## Committee of the Whole

### Staff Report: #PLN-2026-43

**REPORT SUBJECT:** 1126432 Ontario Inc (Easton) Draft Plan of Subdivision 09-T-25004 (Easton Subdivision) – Recommended Township Conditions of Draft Approval

Figure 1: Contributing Area of the Tributary at Crossing of Wolf Grove Road (OWIT)

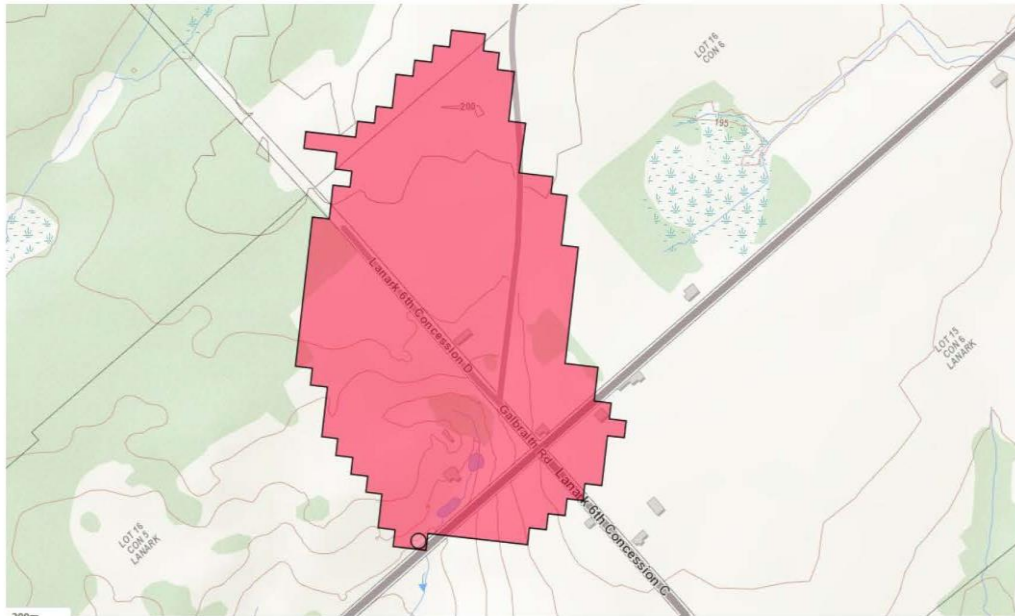
The area contributing to the tributary is roughly estimated to be less than 35ha (see Figure 1). This represents a very small contributing area and would be insufficient to feed a continuously flowing watercourse unless supported by a substantial groundwater source. The landowner notes the presence of a groundwater source to the tributary. Not much is known about the aquifer supporting this spring.
